## Product Change Notice (PCN)

PCN Number: **PCN-0450881R-01**

Product(s) Affected: **PJ1-022**

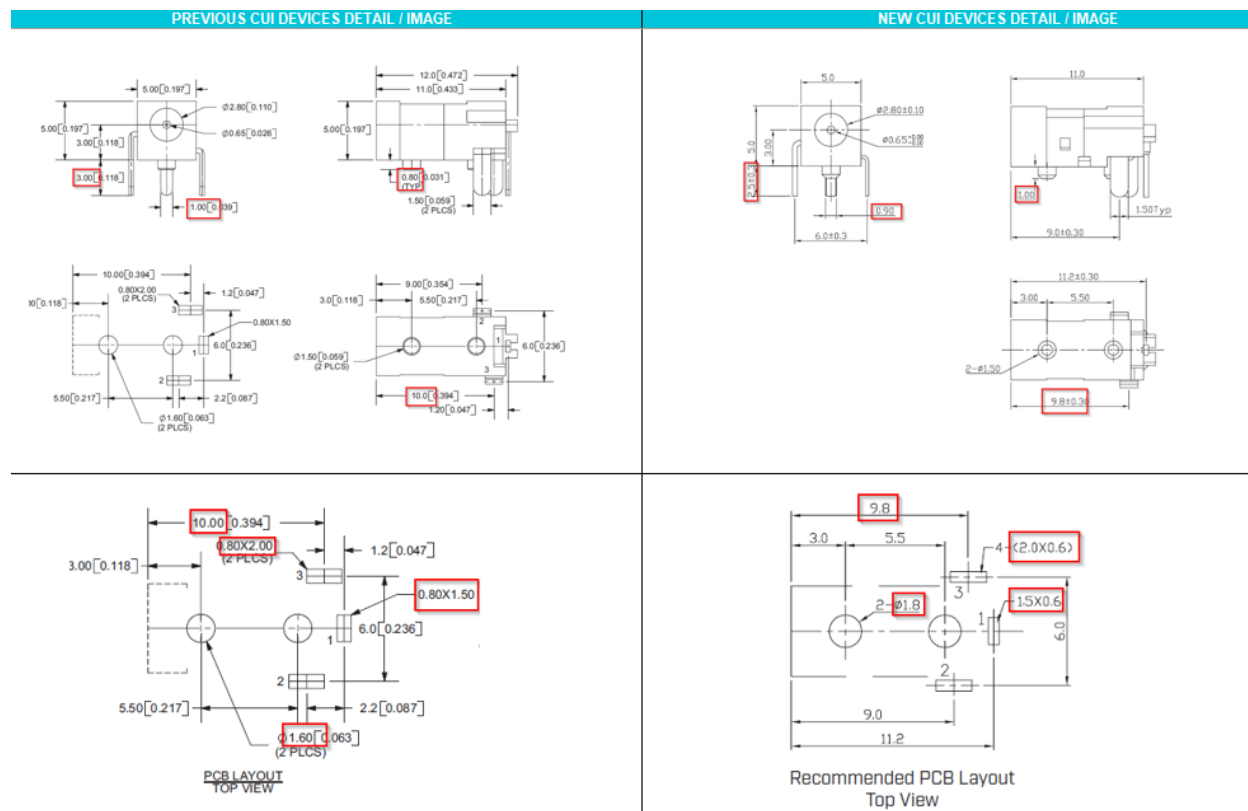
Description of Change: **Minor Housing and footprint differences. Material Change on the housing and terminals. See image Below**

PREVIOUS CUI DEVICES DETAIL / IMAGE			NEW CUI DEVICES DETAIL / IMAGE		
	MATERIAL	PLATING		MATERIAL	PLATING/COLOR
center pin	brass	silver	center pin	brass	silver
terminal 1	brass	silver	terminal 1	brass	silver
terminal 2	copper alloy	silver	terminal 2	Be-Cu t=0.25	silver
terminal 3	brass	silver	terminal 3	brass t=0.40	silver
plastic	PA66		housing	PA66 (UL94V-0)	black
